GROUP	MODEL
BOD	2022MY Stinger (CK)
NUMBER	DATE
302 (Rev 1, 03/04/2022)	August 2021

TECHNICAL SERVICE BULLETIN

SERVICE ACTION: FRONT DOOR TRIM GRIP HANDLE REPAIR (SA483)

This issue number is SA483.

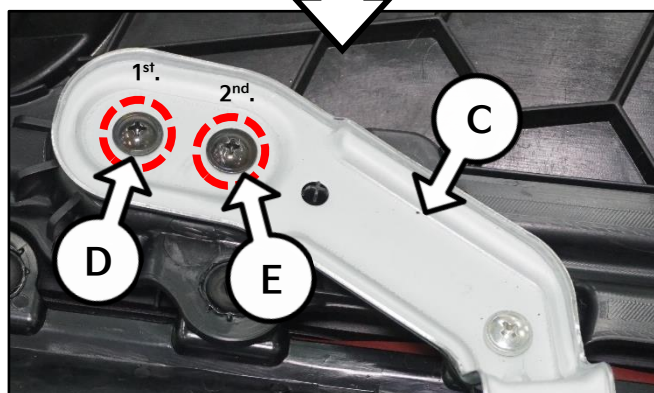
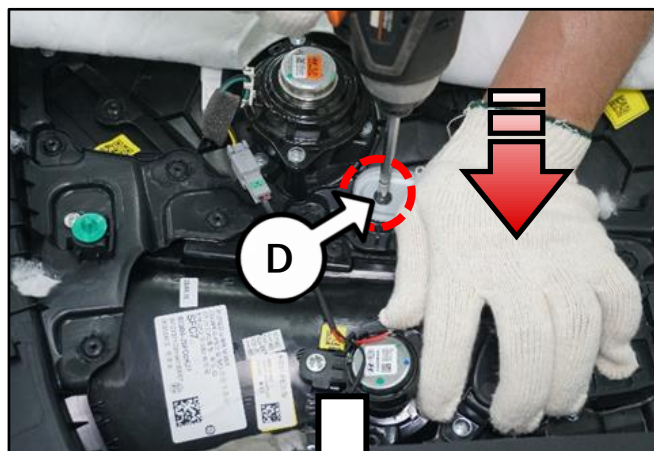
- 4a. Press down on the mounting bracket (C) with one hand as shown.
- 4b. Loosen the outside screw (D) first and install the new longer screw while pressing down.

Continue pressing down on the mounting bracket (C) with one hand as shown.

Loosen the inner screw (E) second and install the new longer screw(s) while pressing down.

Ensure the door trim is on a flat surface. Replace the two (2) screws in the suggested order (D) 1st. & (E) 2nd.

Tightening torque for screw(s):
26.5 - 33.0 lb.ft (12 - 15 kgf.m)
DO NOT OVERTIGHTEN

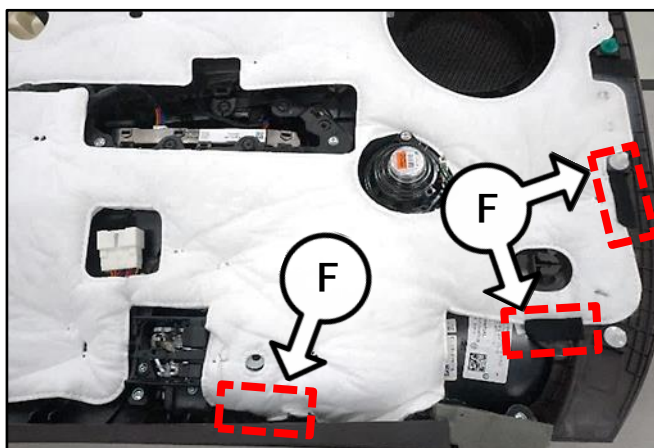
6. Attach the soundproofing felt using the supplied non-woven fabric pads (F) on the edges as shown.
